Informal document **GRSP-INF CRS 26 - XX**
26th meeting of the GRSP INF CRS
5 July 2011

Proposal for amendments to Draft new Regulation on uniform provisions concerning the approval of enhanced Child Restraint Systems used onboard of motor vehicles

The text reproduced below was prepared by the expert from the United Kingdom It is based on Informal Document No. GRSP-49-39. The modifications to the proposed text contained in that document are marked in underline or strikethrough characters.

Paragraph 6.6.4.4.1.1.1., Figure 1

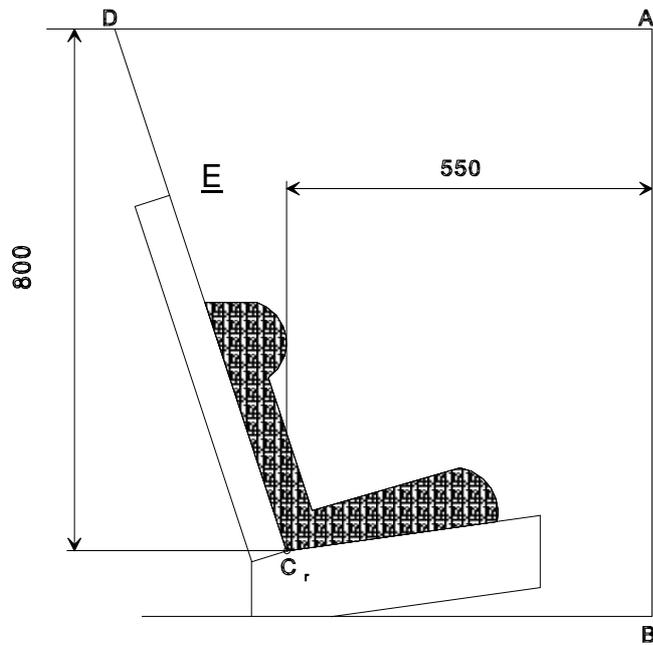
Add node E.

6.6.4.4.1.1.1 Point E has been omitted from diagram..

Example for arm alignment

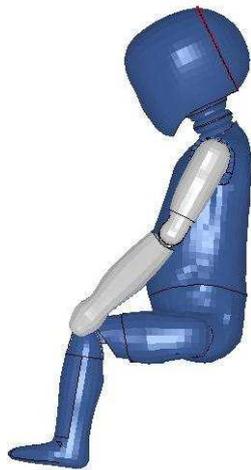
The Arms of the dummy shall be positioned symmetrically. Elbows shall be positioned in such a way that the upper arms ~~are shall be as closely as possible being~~ aligned with the sternum.
